SERVICE BULLETIN

M-1180

SAFETY RECALL-2004 DYNA MODELS THROTTLE CABLE ROUTING

Figure 1. Throttle Cable Routing

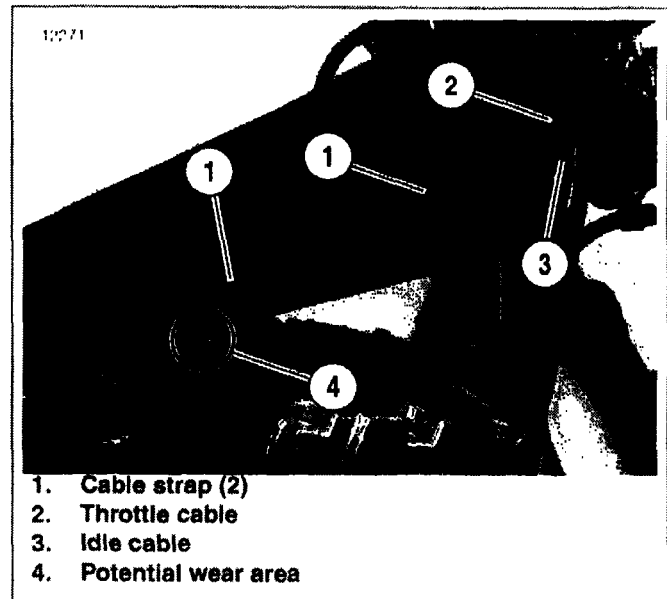
1. Remove fuel tank according to instructions in the 2004 Dyna Models Service Manual.
2. See Figure 1. Remove and discard cable straps (1). Inspect throttle cable (2) and idle cable (3) for wear, particularly the potential wear area (4).
3. Inspect fuel tank for possible wear due to throttle/idle cable contact with tank.

Figure 2. Cable Strap Installation

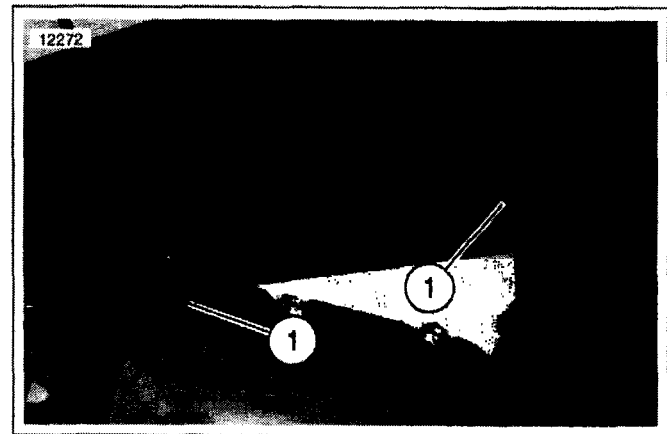
1. See Figure 2. Install **new** cable straps (1) so after installation, ends of cable straps are pointing towards top of vehicle.
2. Install fuel tank according to instructions in the 2004 Dyna Models Service Manual.
3. Complete attached order form for kit 94417.

1. If throttle and/or idle cables are worn, replace cables according to instructions in the 2004 Dyna Models Service Manual.
2. See Figure 2. Install **new** cable straps (1) so after installation, ends of cable straps are facing top of vehicle.

Figure 3. Fuel Tank Inspection Area

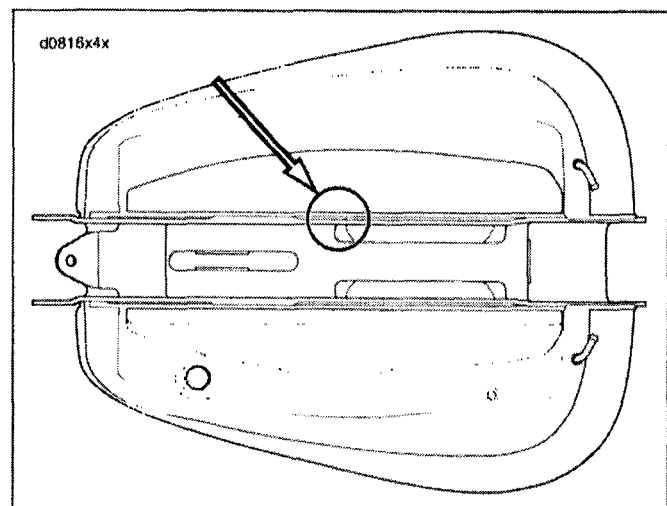
1. See Figure 3. Determine extent of wear on fuel tank:
 - a. If throttle cables have worn or removed paint but have not damaged the metal structure of fuel tank, repair wear using Harley-Davidson Touch-up paint of the correct color.
 - b. If wear has damaged the metal structure of fuel tank, order a new fuel tank according to instructions specified under Credit Procedure.
2. Replace cables according to instructions in the 2004 Dyna Models Service Manual.
3. See Figure 2. Install **new** cable straps (1) so after installation, ends of cable straps are facing top of vehicle.
4. Install fuel tank according to instructions in the 2004 Dyna Models Service Manual.
